Stair flip study · the main stair turned round: start and arrival at the NORTH end, next to the lift · Taif / Palm House V8.0 (work) · STUDY ONLY

ADOPTED 2 Nov 2026 (owner): option B, the freed landing as F-b, the balustrade, the store door onto the riwaq, the half-landing window, the entrance side light, the entry cupboard removed; applied to the design files. Owner's idea, 1 Nov 2026 · the same well (2.75 × 5.7 on axes, 2.525 × 5.50 clear), the same 22 risers × 0.164 / goings 0.28, flights 1.21 clear · nothing in the design files changes until the owner decides · all sizes assumed

1 · The two options on the ground floor

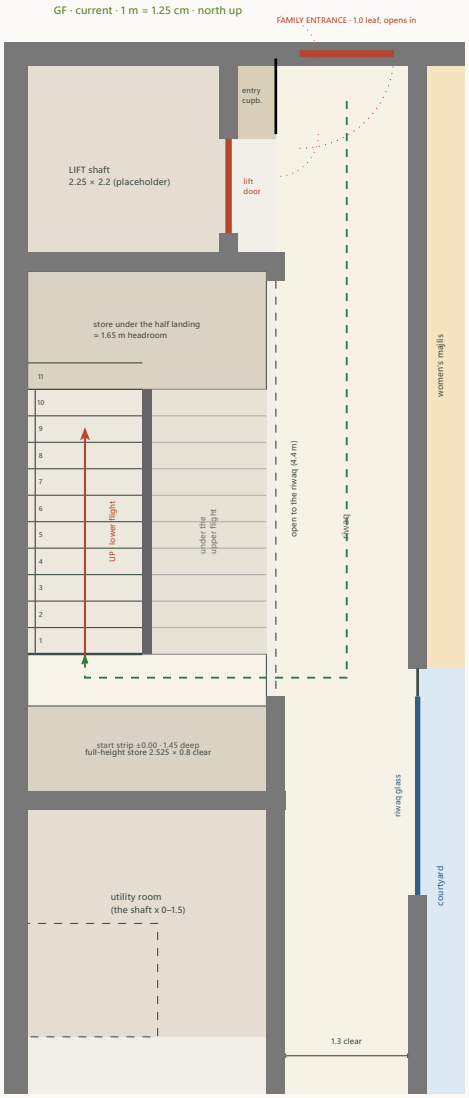
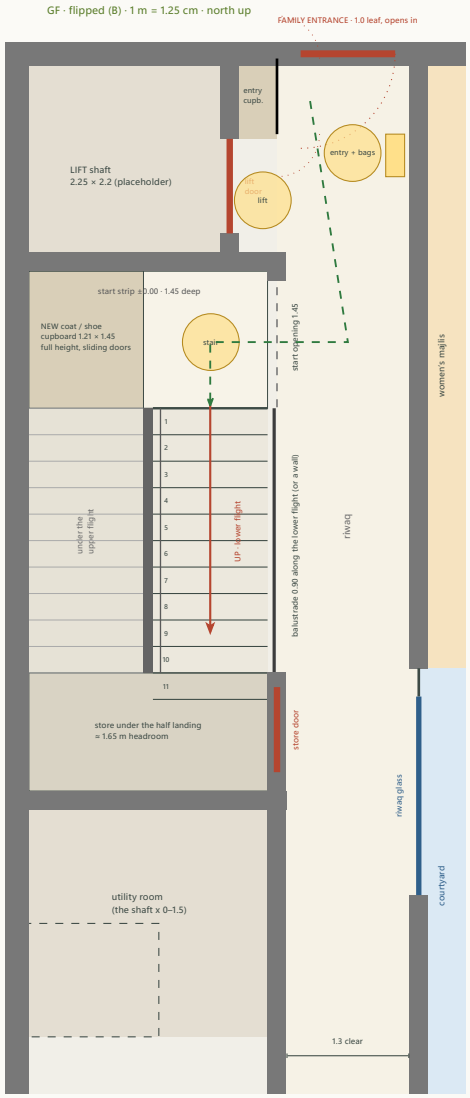
- **Current:** the lower flight on the **west** half starts at the **south** end (first riser y 6.35); the person comes along the riwaq, enters the well through its open east side (4.4 m open) and turns west onto the flight; in front of the first riser only **0.55 m** before the full-height store's wall (the start is really made from the side, under the upper flight's high end). Half landing at the north end (+1.80, a 1.65 m store below it, opening east onto the riwaq); the full-height store 2.525 × 0.8 clear at the south end.

- **Flipped (B, recommended of the two flips):** the lower flight on the **east** half starts at the **north** end (first riser y 3.75), **straight off the lobby**: a 1.45 m opening in the x 2.75 line between the lift notch and the flight, a start strip 1.45 m deep in front of the first riser. The lower flight rises along the riwaq side (a 0.90 balustrade on the riwaq, or a wall: the owner's choice); the half landing at the south end with its 1.65 m store (door onto the riwaq at y 6.7–7.6, in front of the courtyard glass; or into the utility room). The **west half of the start strip** (1.21 × 1.45, full height) becomes a **coat / shoe cupboard** beside the family entrance (sliding doors onto the strip).

- **Flipped (A):** the mirror image only (the lower flight stays west): the person crosses the whole strip to the far half before climbing; no cupboard. Not recommended; everything else below holds for both.

2 · Congestion test at the flipped start (drawn)

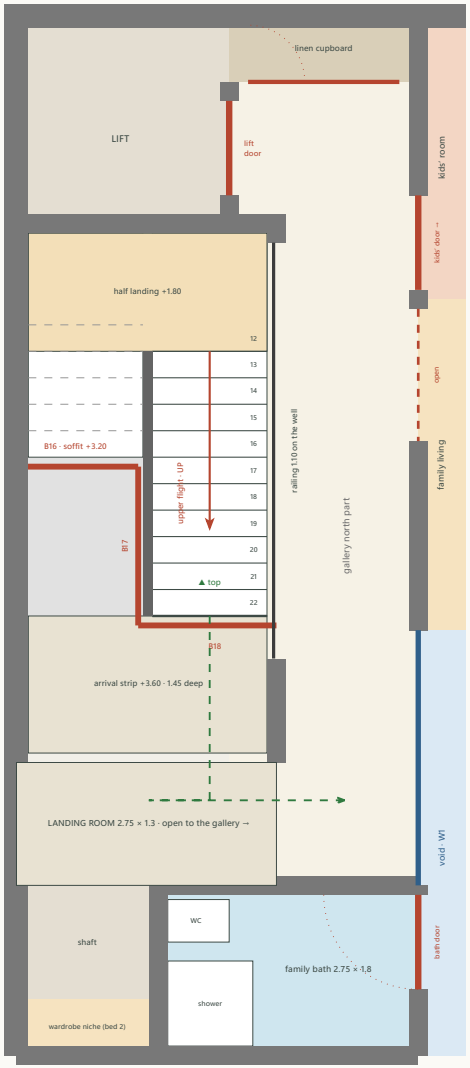
Three people at once: **one waiting for the lift** in the 0.50 m notch in front of its sliding door, **one coming in with bags** inside the family entrance's 1.0 m swing, **one starting up the stair** on the start strip, with the **entry cupboard's two 0.45 leaves open** into the lobby. Clear widths, not axes: the lobby **1.3 m** between the lift / cupboard wall face and the women's majlis wall face (the notch adds 0.5 m at y 0.9–2.2); the start opening **1.45 m**; the first riser **1.21 m** wide; the entrance **0.9 m** clear. The three stand in three separate zones along the lobby (y 0–1.0 the door swing, y 0.9–2.2 the lift notch, y 2.3–3.75 the start strip); the stair starter passes 0.3 m south of the lift waiter and never crosses the entrance swing: **OK**. Two people can pass in the 1.30 m lobby (0.60 + 0.60 + 0.10) but a person with two bags blocks it for a moment, as today. **Furniture up the stair:** the 90° turn from the 1.30 lobby through the 1.45 opening onto the 1.21 flight is a tight but normal house stair turn; the current start (0.55 m strip, sideways) is worse.

FF · current · 1 m = 1.25 cm · white = opening · grey = slab

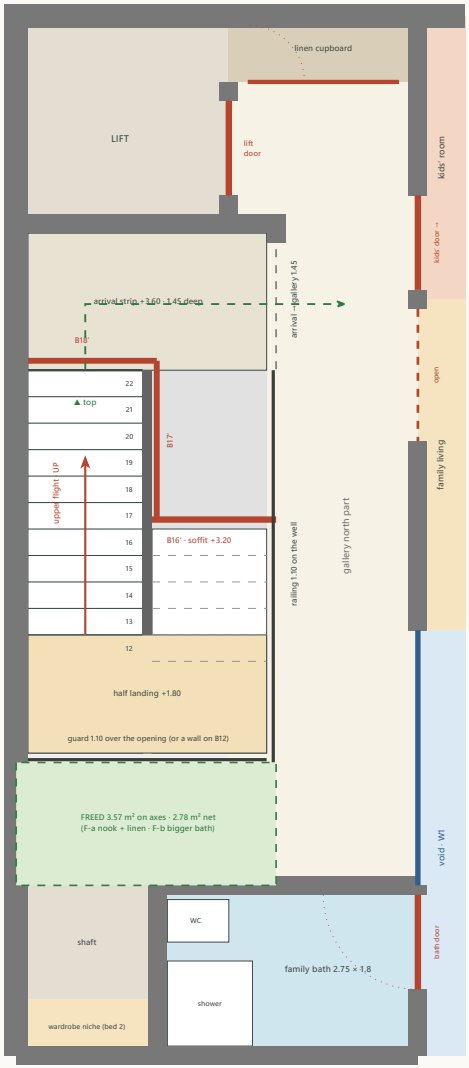
- **Current:** the upper flight (east half) lands at +3.60 on the arrival strip (y 6.35–7.8), then the **landing room** (2.75 × 1.3, y 7.9–9.2) and east into the gallery; the bedrooms and the family bath are at hand, the kids' room, the living and the lift are 6–9 m north along the gallery.

- **Current (studies/structure.typ):** an L-shaped opening ≈ 8.2 m²: the west half open from the north wall to B16 (y 4.85), the east half open to B18 (y 6.45); B16 (0.20 × 0.40, soffit +3.20) from the west wall to B17; B17 (x 1.29, on the lower flight's side of the split) from B16 to B18; B18 (y 6.45) from B17 to the riwaq-line beam B10 (x 2.75).

FF · flipped (B) · 1 m = 1.25 cm · white = opening · grey = slab

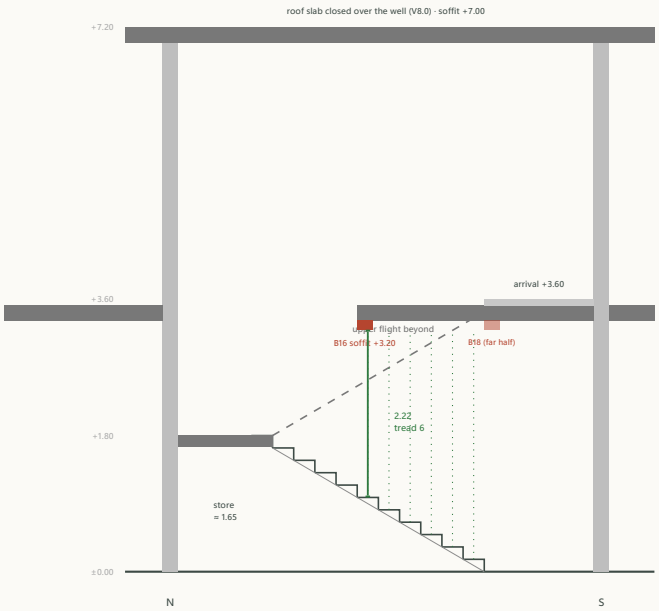
- **Flipped (B):** the upper flight (west half) lands on the arrival strip at the **north** end (y 2.3–3.75); the strip opens east onto the gallery's north part (1.45 m), **0.10 m south of the lift notch**: the lift's first-floor door, the linen cupboard (its leaves swing south, 0.6 m), the kids' room door (opens into the room) and the family living's opening are all within 1–3 m. The gallery's north part (1.30 clear) carries the arrival traffic as it carries the lift's today; the linen leaves and the lift door are 1.0 m north of the arrival: no clash. The railing on the well runs from the arrival (y 3.75) to the south wall; the landing room is **freed** (§ 5).

- **Flipped (B):** the **same opening turned round** (≈ 8.2 m²): the east half open from B16′ (y 5.33) to the south wall, the west half from B18′ (y 3.65) to the south wall. **B16′** (y 5.33) from the riwaq-line beam B10 to B17′; **B17′** (x 1.49, on the east, lower flight's side of the split: never over the upper flight) from B16′ to B18′; **B18′** (y 3.65, the arrival edge) from the west wall to B17′. The same zigzag, mirrored: one beam-on-beam junction at each end of B17′, the torsion the engineer's; B18′ now bears on the west wall (as B16 does today) and B16′ on B10 (as B18 does today). **Neither better nor worse** for the structure: the spans (1.3–1.6 m) and the bearings are the same kind. **Not verified.**

- **Slab edges:** the arrival strip (1.45 × 2.525) spans between the north wall beam B11 (y 2.2) and B18′; over the lower flight's first six treads the slab spans from B18′ to B16′ (1.6 m) between B10 and B17′. The guard round the opening: the railing on x 2.75 from the arrival south to y 7.9, the well's south wall line y 7.9 (a 1.10 guard or a wall on B12), the upper flight's balustrade on the split.

Headroom · a section along the lower flight for each option · the slab 0.2 thick (soffit +3.32), the trimmers 0.20 × 0.4 (soffit +3.20), the finish 0.08 · over the full walking width of every tread

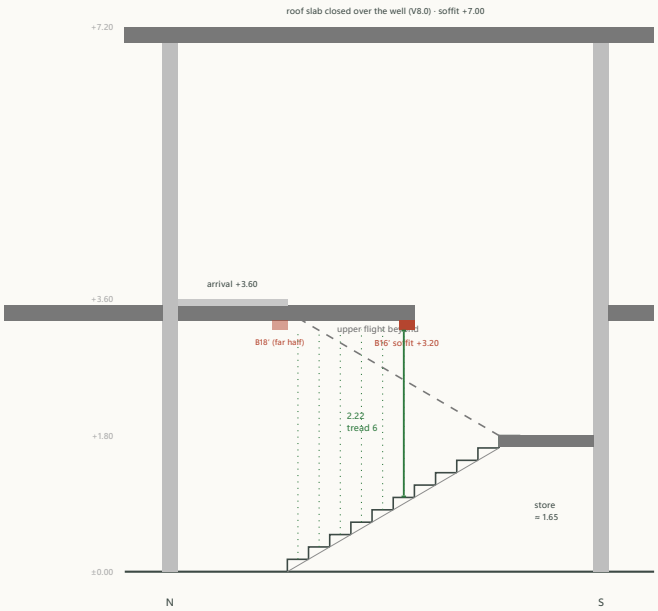
The upper flight, the half landing and the arrival are under the open well (the roof slab's soffit +7.00): ≥ 3.4 m. Minimum of this option: **2.22 m** at tread 6 under the trimmer, across the whole 1.21 m width (the trimmer spans the half); B17 over the inner 0.10 strip of treads 1–5: ≥ 2.38 m.

The upper flight, the half landing and the arrival are under the open well (the roof slab's soffit +7.00): ≥ 3.4 m. Minimum of this option: **2.22 m** at tread 6 under the trimmer, across the whole 1.21 m width (the trimmer spans the half); B17′ over the inner 0.10 strip of treads 1–5: ≥ 2.38 m.

Verdict on the headroom: identical in both options (**2.22 m** at tread 6 under the trimmer, 2.83 m at tread 3 under the slab; ≥ 2.10 required, the 2.20 aim just met) because the flip mirrors the geometry: the trimmers sit in the same places relative to the treads. **The flip neither improves nor worsens the trimmers.** What would improve both: trimmers 0.20 × **0.30** (soffit +3.30 → **2.32 m** at tread 6) if the engineer accepts a 0.30 depth for the 1.3–1.6 m spans, or the slab edge moved one tread (the opening 0.28 m longer, ≈ 0.35 m² more void, tread 6 under open sky → the minimum moves to tread 5: 2.38 m). Both options can take either. The walls' handrails run the full flights (0.08 off the walls); the central handrail on the 0.10 split.

- **Conditions:** (1) a glazed panel / side light in the family entrance (or a lobby window) and a **west window at the half landing** so the start and the well are not dark; (2) the **balustrade** along the lower flight on the riwaq side, 0.90 m, black steel in the design language (not a wall), so the riwaq keeps its width of view; (3) the freed landing as **F-b, the two-compartment family bath** (the WC by the shaft, a second basin), or F-a if the owner prefers a nook; (4) the half-landing store's door onto the riwaq (household) — or into the utility room (service), the owner's choice; (5) the headroom improvement, open to both: ask the engineer for **0.30 trimmers** (2.32 m at tread 6) before the slab is detailed.
